P802.3ck D2.0

Clause/Annex 163, 163B, 120F

Comment Resolution

Phil Sun, Credo Semiconductor
Matt Brown, Huawei, 802.3ck Editor-in-Chief

Figure 163-6—Channel insertion loss limit

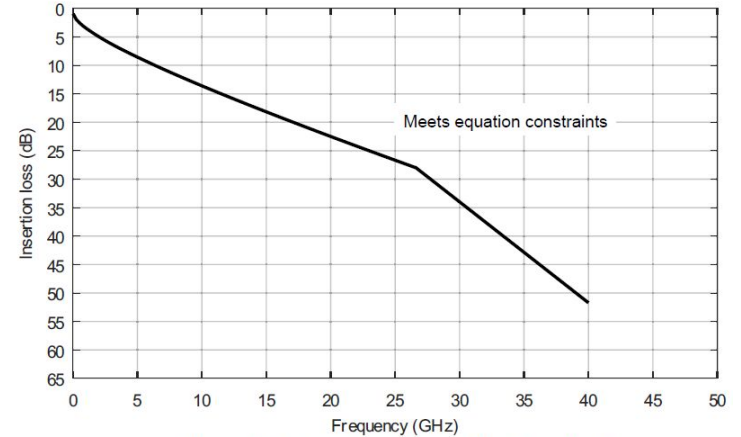
51.8 dB at 40 GHz, at least 23.3 dB beyond the loss at Nyquist and further filtered by the transmitter and receiver, is unlikely to affect performance and may exclude some acceptable channels which are good to 30 GHz then less good at 40.

Replace the straight part of the limit with one that curves down (with an f^2 term), with a reduced f_{max} .

PROPOSED REJECT.

The suggest remedy does not provide sufficient detail to implement.
